Eastern Creek Business Hub Retail Centre

*State Significant
Development
Modification Assessment
(SSD 8588 MOD 3)*

November 2019

Figure 4 | Proposed site layout changes

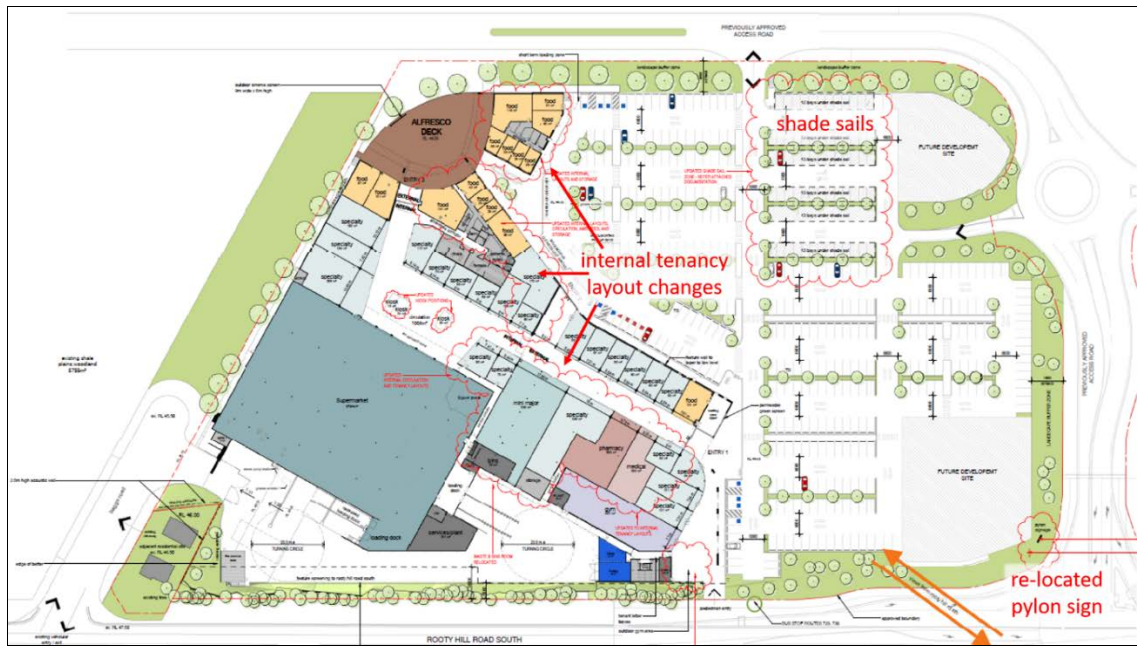
- the proposed outdoor gym space should be defined to ensure the space does not conflict with pedestrian access and the use is to be managed to ensure it does not adversely impact the public in regard to noise, obstruction and views
- the turning circle for the servicing of the supermarket has decreased from 27 m to 23 m in diameter and concern raised about adequate space for manoeuvring for the largest size truck proposed to service the supermarket. If a semi-trailer is unable to manoeuvre, this is to be conditioned and signposted accordingly.

The proposal seeks to install shade sails in the carpark over 77 car spaces (**Figure 4**). The Applicant advises the shade sails are required to provide additional sun protection and support the leasing of major tenancies in the centre.

- updated plans showing acoustic screening and the proposed changes to the screening material
- updated shade sail and landscape plan and a statement from a landscape designer
- revised signage strategy correctly identifying the location of sign N and O and a statement from a lighting engineer regarding illumination levels
- updated plans showing the outdoor gym area and the retention of a 27 m diameter turning circle in response to Council's concerns

Supermarket turning circle	<ul style="list-style-type: none"> • Council noted the turning circle to service the supermarket loading area had decreased from 27 m to 23 m in diameter and queried if this provided sufficient manoeuvring for a semi-trailer. • In response, the Applicant provided an updated site plan which shows a 27 m turning circle for the supermarket loading dock and manoeuvring for a 19 m vehicle. • The Department is satisfied there is no change to the approved supermarket loading dock access and there is sufficient space to 	No additional conditions or amendments to existing conditions necessary.

Figure 6 | Location of proposed signs N and O

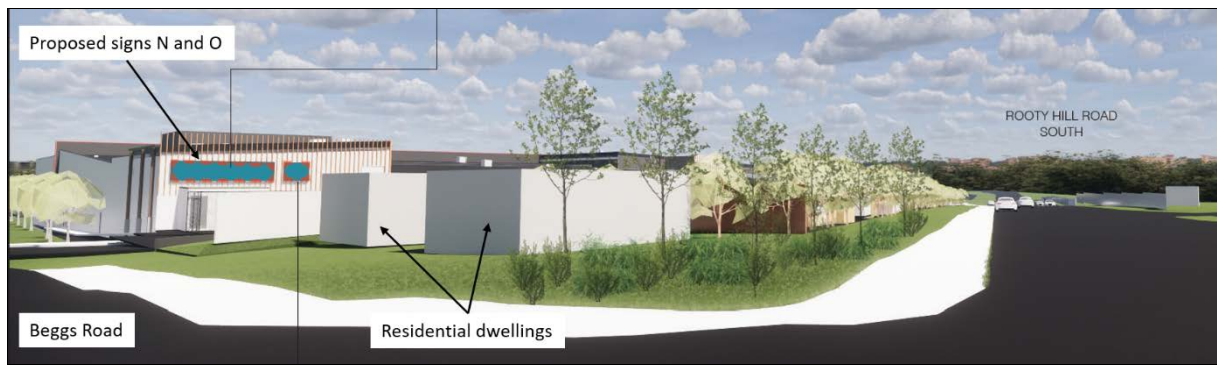
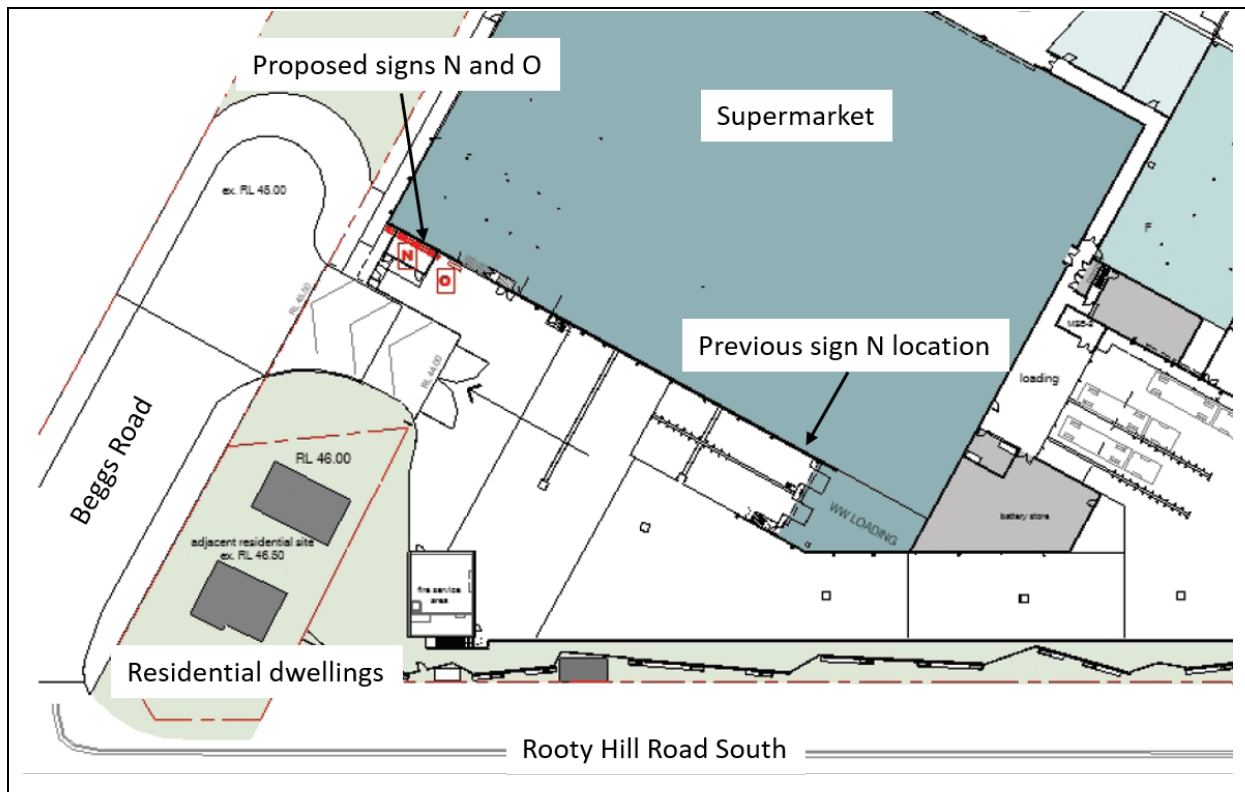
Signs N and O are anchor tenant signs located on the western facing elevation of the retail centre, directly behind a residential dwelling at the corner of RHRS and Beggs Road (**Figures 6 and 7**). The Department raised concerns about adverse amenity impacts from these two signs to the residential dwelling and requested the Applicant consider relocation or provide justification for the location of these signs.

In response the Applicant amended the proposal and provided further information in relation to signs N and O including:

- removal of illumination
- planting of two advanced growth *Cupaniopsis anacardioides* trees in the deep soil zone adjacent to the rear of the residential dwelling.

The Department has considered the Applicant's response and supports the changes to signs N and O for the following reasons:

- the removal of illumination will significantly reduce any adverse amenity impacts to the residential dwelling
- the proposed trees will have a mature height of 8 m and width of 6m (**Figure 8**), and are capable of screening the signs from the residential dwelling, reducing adverse visual impacts
- the proposed species (*Cupaniopsis anacardioides*) is a native tree and is consistent with and compliments existing approved landscaping for the site.

The Department recommends two new conditions prohibiting any illumination of signs N and O and requiring two advanced growth *Cupaniopsis anacardioides* trees to be planted.

Figure 9 | Proposed shade sails and landscaping in the carpark

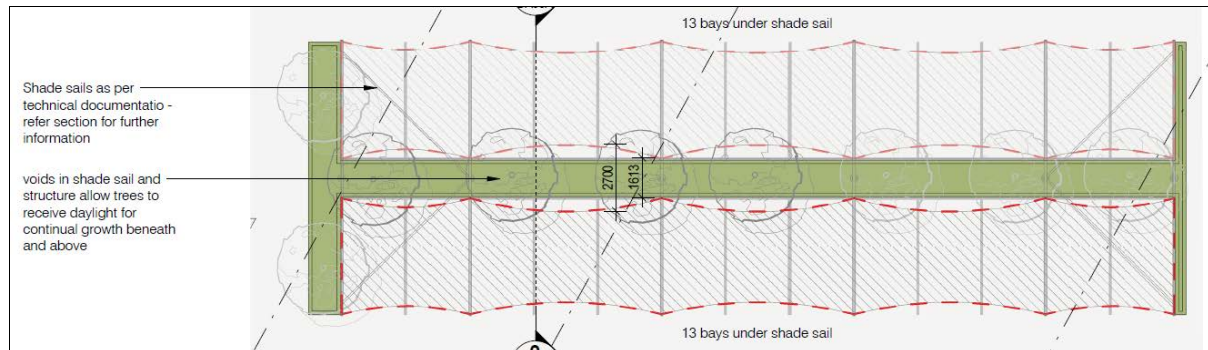
In response to the Department's request for information about how the shade sails will integrate with the carpark landscaping, the Applicant, in its RTS, provided a statement from a landscape architect and a shade sail landscape plan.

- advice from a certified landscape designer has been provided confirming there is sufficient space to plant seven Spotted Gum Trees in each landscaping row between the car spaces (as per the approved landscape plan) and the void between the shade sails will enable tree growth, subject to a maintenance schedule to monitor tree branches during establishment of the mature trees (**Figure 9**)

The Department recommends that Condition B5 (detailed landscape plan) is amended to require the landscaping maintenance schedule be updated to include the requirement to monitor the trees planted in the shade sail carpark void. Subject to this, the Department is satisfied with the addition of shade sails to the carpark.
